REV. SH				REV. SH			
VAR	ZN	DESCRIPTION	VAR	ZN	DESCRIPTION		
4	VAR	44 REVEALED RAMP DECK CUT, FR 87 TO 101 PORT TO SUIT DEVELOPMENT.	1	VAR	1. ON "AB" DECK-REMOVED HVAC FANS & PLENUMS AT SHELL P/S TO SUIT DEVELOPMENT.		
5	VAR	45 DELETED RAMP STOPS, FR 24 TO 35 TO SUIT DEVELOPMENT.	2	VAR	2. "B" DECK-REMOVED STAIRS AT SHELL TO SUIT DEVELOPMENT.		
13-B	VAR	46 DELETED ELEVATION DOORS "A" & "B" DECKS TO ELIMINATE ELEVATOR STOPS AT CARGO HOLD AS PER REVISED SPECIFICATIONS.	3	VAR	3. REMOVED ALL INDICATORS FOR FAN ROOMS AND FAN ENCLOSURES AT "B" DECK TO SUIT DEVELOPMENT.		
		BTSM 8/11/94	15-B	VAR	4. CORRECTED STERN OVERHANG AT "B" DECK TO SUIT DEVELOPMENT OVERHANGING PLATFORMS.		
		APD/DEL 8/11/94	15-D	VAR	5. DELETED TRUNKS "B" BHP 20.		
B	VAR	1. UPDATED FAN ARRANGEMENT ALONG SHELL P/S TO SUIT VENTILATION DEVELOPMENT.	5-C	VAR	6. DELETED FAN RM & ADDED STARTOWER AFT FR 50		
14-C	VAR	2. INDICATED BERN STERN ONLY FOR RUDDER STOP REMOVAL AND INCREASED SIZE OF HATCH PORT SIDE TO SUIT DEVELOPMENT.	10-C	VAR	8. DELETED STARTOWERS & VENT TRUNKS "C" FR 71.

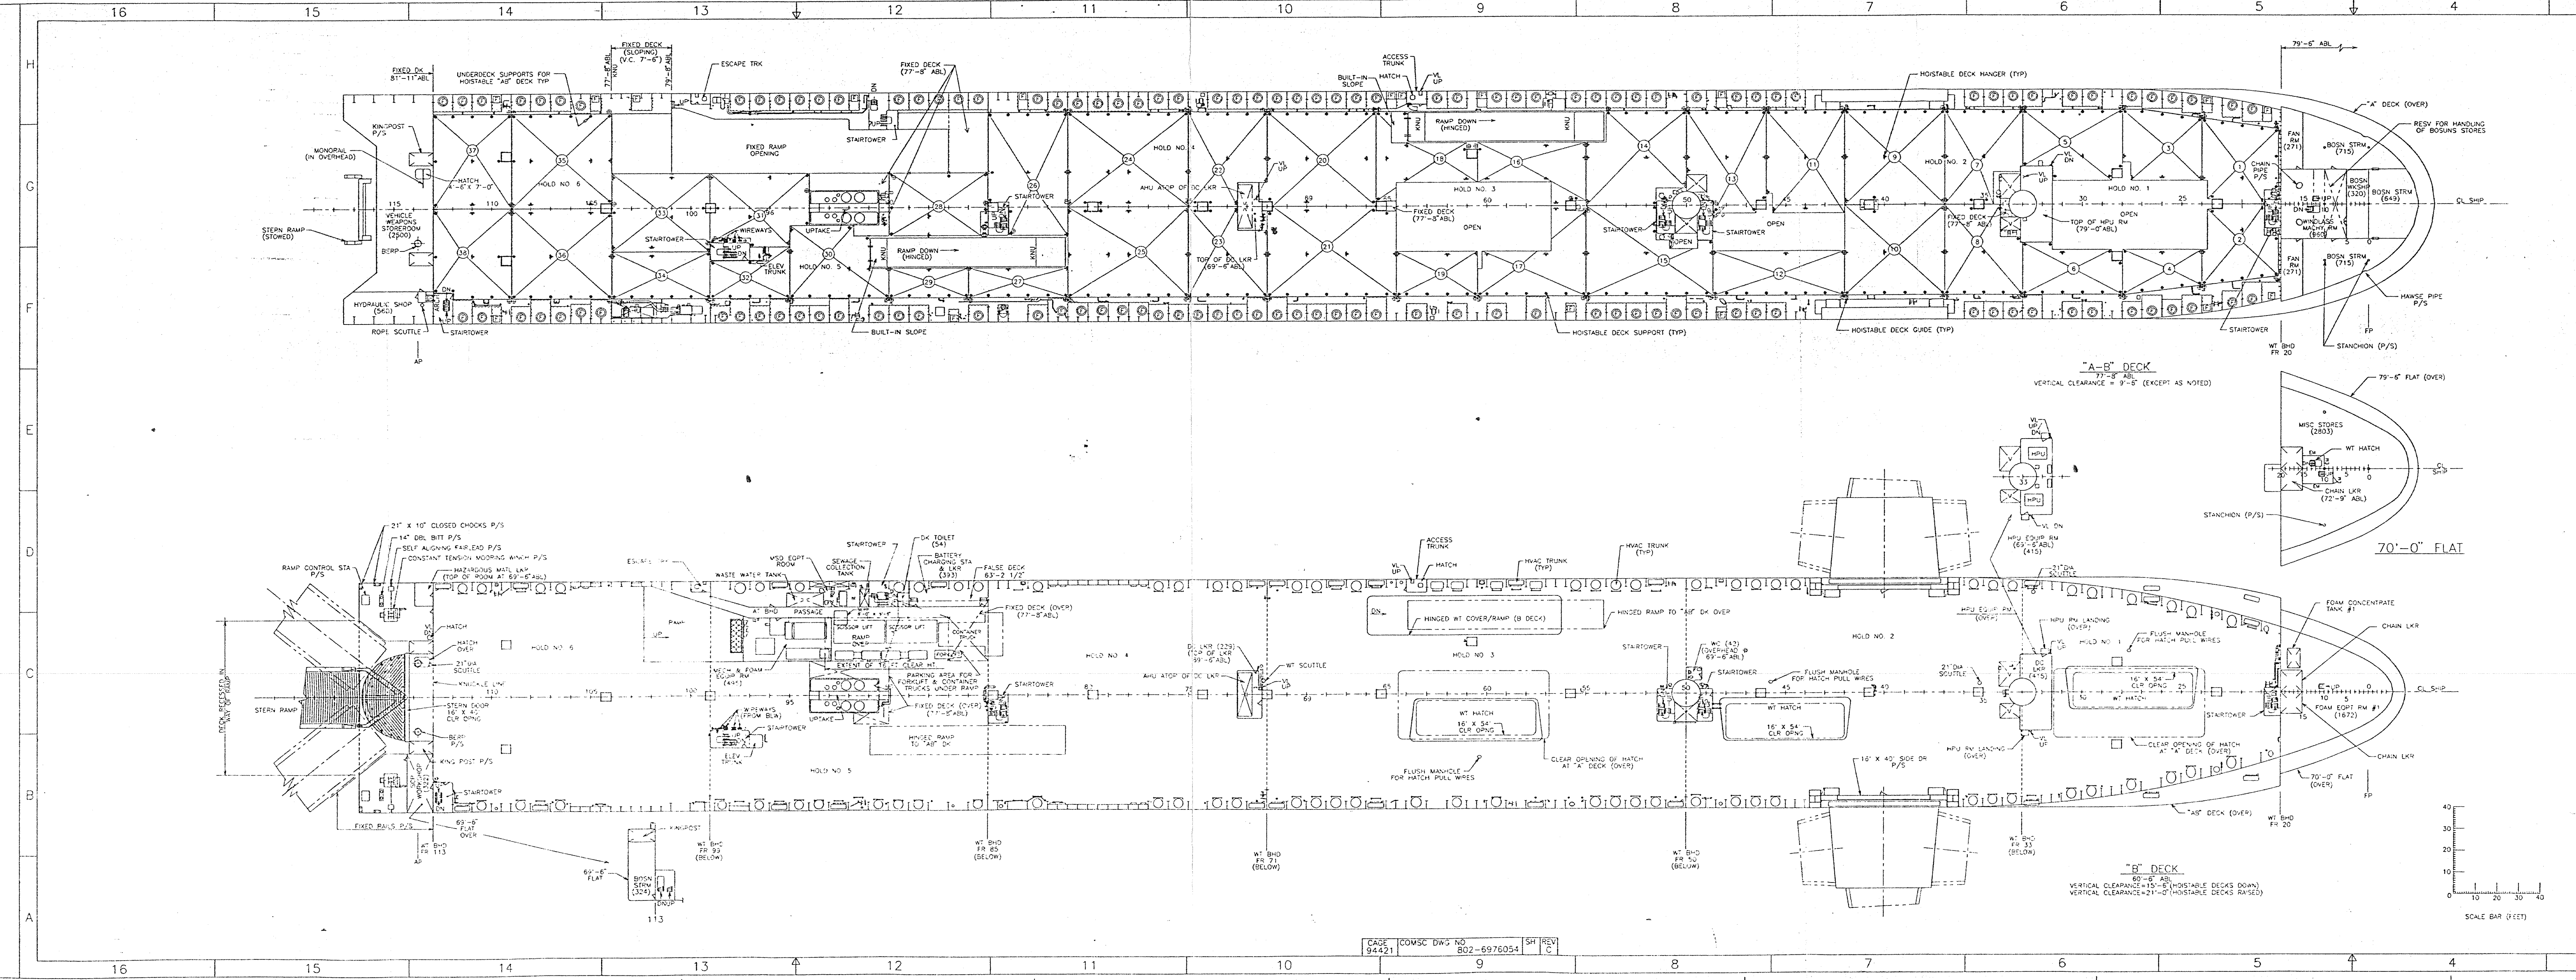
VAR	3	3. RELOCATED SIDE PORT DOORS TO CENTER ON FR 40 TO SUIT DEVELOPMENT.	10-D	VAR	9. ADDED STARTOWER FR 85.		
VAR	4	4. CHSD (3) FAN ROOM STBD ONLY TO 11"-O" TO SUIT DEVELOPMENT.	14-C	VAR	10. DELETED VENTS FR 113.		
5-C	VAR	5. RELOCATED "A" & "B" DECK AND CORRECTED "AB" DECK TO SUIT VENTILATION DEVELOPMENT.	15-D	VAR	11. DELETED VENT TRUNKS "B" BHP 20.		
6-C	VAR	6. MODIFIED STERN OF "AB" & "B" DECKS TO CORRECT.	18-H	VAR	12. DELETED WC & VENT TRUNKS "C" FR 33.		
VAR	7	7. REVISED ESCAPE TRUNK "B" FR 90 TO SUIT DEV.	18-C	VAR	13. DELETED WC TRUNKS & ADDED STARTOWER AFT FR 50.		
4-B	VAR	8. DELETED LONG MT BHD'S P/S ON "70"-O" FLAT TO SUIT DEVELOPMENT.	14-C	VAR	14. DELETED STARTOWERS & VENT TRUNKS & RELOCATED LMS "C" FR 113.		
13-D	VAR	9. MOVED DOOR FROM TRANSV BHD TO LONG BHD TO SUIT DEVELOPMENT.	18-H	VAR	15. DELETED ESCAPE TRUNK "C" FR 50 FROM FR 71.		
14-D	VAR	10. CHSD ABL DIMENSION AT FWD END OF SLOPING DK FROM "80"-E" TO "79"-S" TO CORRECT.	18-C	VAR	16. RELOCATED ESCAPE TRUNK FROM FR 85 TO FR 71 ON "AB" & "B" DECKS.

8-C	VAR	11. ADDED VENT CUTS AND CONFIGURATION OF HOSTABLE DECK SECTIONS TO SUIT.	13-G	VAR	17. MODIFIED LITTLE BECKS ALONG FIXED RAMP.		
VAR	12	12. INDICATED STANCHIONS AT FRs 87,89,91,93 & 95, PORT SIDE IN WAY OF "A" DECK TO CORRECT.	9-C	VAR	20. DELETED DECK MOULGE LIMS FROM "AB" & "B" DECKS.		
13-C	VAR	13. DELETED CLOSURE PLATE BWN STARTOWER AND VENT AREA TO AVOID INTRUSION.	9-C	VAR	21. DELETED COLUMN AT FR 62 FROM "AB" & "B" DECKS.		
VAR	14	14. DELETED ALL NATURAL CARGO SUPPLY VENT TERMINALS ON "AB" DECK TO SUIT DEVELOPMENT.	9-C	VAR	22. RELOCATED COLUMN FROM FR 65 TO AFT FR 85 ON "AB" & "B" DECKS.		
5-C	VAR	15. "AB" DECK-MOVED TRANSV BHD'S P/S FROM "B" FWD FR 15 TO FR 15 TO SUIT STRUCTURAL DEV.	9-C	VAR	23. REVISED ELEVATIONS OF FLATS FWD FR 20 TO SUIT LOWERING.		
VAR	16	16. "AB" DECK-CHANGED CONFIGURATION OF HOSTABLE DECK SECTIONS TO AGREE WITH LATEST VENDOR DWG DATED 12/22/94.	3-C	VAR	24. ADDED GENERAL NOTE, ABBREVIATION AND SYMBOL.

VAR	17	17. RELOCATED STERN RAMP, FR 81-91 AND PORT RAMP, FR 54-64 FROM "20"-O" TO SUIT HULL DEV.	23-C	VAR	25. ADDED SCALE BAR.		
VAR	18	18. "AB" DECK-HIGH RAMP FROM "20"-O" TO SUIT RAMPED TO SUIT VENDOR DWG DATED 5/15/95.	4-C	VAR	26. INDICATED VERTICAL LADDERS IN CARGO HOLD STARTOWERS.		
14-B	VAR	19. HEIGHT OF BOSUN'S STERN CHGD FROM "20"-O" TO "60"-E" TO ALLOW OVERHUNG P/S FROM "20"-O" MONDRAIL.	5-C	VAR	27. LABELED OUTLINE OF HATCH COVER.		
13-H	VAR	20. REVISED VENT FAN ENCLOSURE FR 102 TO 103, PORT TO SUIT VENTILATION DEVELOPMENT.	28	VAR	28. INDICATED MT TRANS BHD'S BETWEEN FR 33 & 99 AS (BELOW).		
VAR	21	21. GENERALLY REVISED TO UPDATE WITH C & A DWGS.	5-F	VAR	29. DELETED LMS FROM COMPARTMENT DESIGNATIONS FOR AFT EQUIPMENT ROOM.		
13-D	VAR	22. REVISED SIDE OF VENT ENCLOSURE BWN FRs 105 & 106 TO SUIT VENT DEV.	5-F	VAR	30. DELETED MISC STERN AT "AB" DECK FR 15 (P) & LONG CENTER AT FR 15 (S). EXTENDED FAN ROOMS TO SUIT.

13-C	VAR	23. DELETED INDICATION OF BERN AT FR 100, STBD SIDE "AB" & "B" DECKS.	5-D	VAR	31. LABELED "AB" DECK RAMP AS MINGED.		
VAR	24	24. UPDATED RAMP DECK CUTS TO SUIT STRUCTURAL DEV.	32	VAR	32. DELETED LMS FROM COMPT DESIGNATION FOR MISC STORES ON "70"-O" FLAT.		
13-C	VAR	25. INDICATED WIREWAYS WITH APPROPRIATE DECK PENETRATIONS AT INBD SIDE OF STARTOWER, FRs 97 TO 99, STBD TO SUIT.	10-C	VAR	33. ADDED MT DOOR IN TRANSV BHD AT FR 113 (P) AND IN TRANSV BHD "3"-OFT FR 114 (S) FOR ACCESS TO MOORING STATION.		
10-C	VAR	26. ADDED MCH PROTECTION FOR RECTANGULAR VENTS.	14-C	VAR	34. STANCHION IN HOLD NO. 35, PORT SIDE MOVED FROM FR 62 TO FR 62 TO FWD SIDE OF FR 61 TO SUIT DEVELOPMENT.		
VAR	27	27. "B" DECK-UPDATED "RAMP OVER" OUTLINES TO SUIT.	8-B	VAR	35. REVISED STARTOWER AT FWD AND AFT SIDE OF FR 20 AT "AB" DECK TO SUIT STRUCTURAL DEVELOPMENT.		
13-C	VAR	28. CORRECTED SIZE OF REV STORAGE ARRANGEMENT OF SCISSORS LIFTS TO SUIT.	10-C	VAR	36. DELETED ESCAPE TRUNKS AT FWD AND AFT SIDE FR 33 AND ADDED VLS & HATCHWAYS AS PER DEV.

13-B	VAR	29. DELETED DOORS FR 97 TO OUTBOARD SIDE OF STARTOWER "AB" & "B" DECKS TO SUIT DEVELOPMENT.	12-B	VAR	37. REVISED INCLINED LADDER, FR 10, FROM STACKED TO SUIT STRUCTURAL DEVELOPMENT.		
30	VAR	30. INDICATED HINGED MT COVER/RAMP "B" DECK IN LIEU OF FIXED RAMP AND HINGED MT COVER.	10-C	VAR	38. DELETED BERN BWN FR 93 & 94 AND INDICATED NEW BERN BWN FR 100 & 101 TO SUIT DEV.		
31	VAR	31. ADDED 21 DIA SCISSOR "B" DECK FR 113 PORT TO ESCAPE FROM STEERING CARGO ROOM.	10-C	VAR	39. RESIZED & RELOCATED BERN AT "AB" DECK TO SUIT.		
14-C	VAR	32. CORRECTED SIZE OF STERN KING POST AND LOCATED STERN DOOR TO SUIT DEVELOPMENT.	10-C	VAR	40. DC LMS MOVED FROM FWD SIDE OF STAN AT FR 71 TO AFT SIDE TO SUIT DEVELOPMENT.		
14-C	VAR	33. PLATED MOORING STANCHIONS TO SUIT DEVELOPMENT.	10-C	VAR	41. INDICATED DC LMS UP ON "B" DECK PLAN AND REVISED CUTS OF HOSTABLE DECK PORTIONS AFFECTED BY DELETED TRUNKS & AIR HANDLING UNITS (AHU) TO SUIT DEVELOPMENT.

APD/DEL 6/21/95	VAR	VAR	42. DELETED V		
		APD/DEL 6/25/95					
C	VAR	1. UPDATED VENTILATION ARRGT TO SUIT STRUCTURAL DEV.			CONT NEXT COLUMN		
14-D	VAR	2. ADDED LOCATING DNG FOR HAZARDOUS MAIL LMR TOP.					
8-B	VAR	3. RELOCATED WC FR 50 TO "A" & REV SQUARE FOOTAGE TO SUIT COMPOSITE DEVELOPMENT.					
VAR	4	4. VERTICAL LADDERS IN ALL STARTOWERS TO SUIT FR FWA-67.					
5	VAR	5. RELEASED RES #1 TO SUIT DEV.					
6	VAR	6. REVISED CORP. NO. IN "B" DECK TO CORRECT.					
12-C	VAR	7. "B" DECK-INDICATED FIXED DECK OVER BWN FRs 85 & 94.					
13-B	VAR	8. INDICATED ROPE SCUTLE IN HYDRAULIC SHOP FOR BOSUN'S STOREROOM TO CORRECT.					
VAR	9	9. INDICATED PIPE STANCHIONS AT FR 0 AND FR 10 TO CORRECT.					
10-C	VAR	10. INDICATED CHAIN PIPE PASSING THROUGH WINGWASH MACH RM TO CORRECT.					
14-B	VAR	11. "B" DK ADDED BERN P/S, AT APPROX. FR 114 FOR RUDDER STOP REMOVAL, "70"-O" FLAT. INDICATED EXPANDED METAL BHD'S ALONG STAIRS TO SUIT OUTFITTING DEVELOPMENT.

12	VAR	12. GENERALIZED UPDATED PLANNING TO SUIT DEVELOPMENT.					
		ITEMS #5, 10 & 11 TO SUIT CORP 2205-250 6-0022.2, DATED AUG. 22-1995.					
		APD/DEL 8/11/94					
		APD/DEL 8/11/94					
		2 1997					
		2 1997					
		2 1997					
		2 1997					
		2 1997					
		2 1997					
		2 1997					
		2 1997					
		2 1997					
		2 1997					
		2 1997					
		2 1997					
		2 1997					
		2 1997					
		2 1997					
		2 1997					
		2 1997					
		2 1997					
		2 1997					
		2 1997					
		2 1997					
		2 1997					
		2 1997					
		2 1997					
		2 1997					
		2 1997					
		2 1997					
		2 1997					
		2 1997					
		2 1997					
		2 1997					
		2 1997					
		2 1997					
		2 1997					
		2 1997					
		2 1997					
		2 1997					
		2 1997					
		2 1997					
		2 1997					
		2 1997					
		2 1997					
		2 1997					
		2 1997					
		2 1997					
		2 1997					
		2 1997					
		2 1997					
		2 1997					
		2 1997					
		2 1997					
		2 1997					
		2 1997					
		2 1997					
		2 1997					
		2 1997
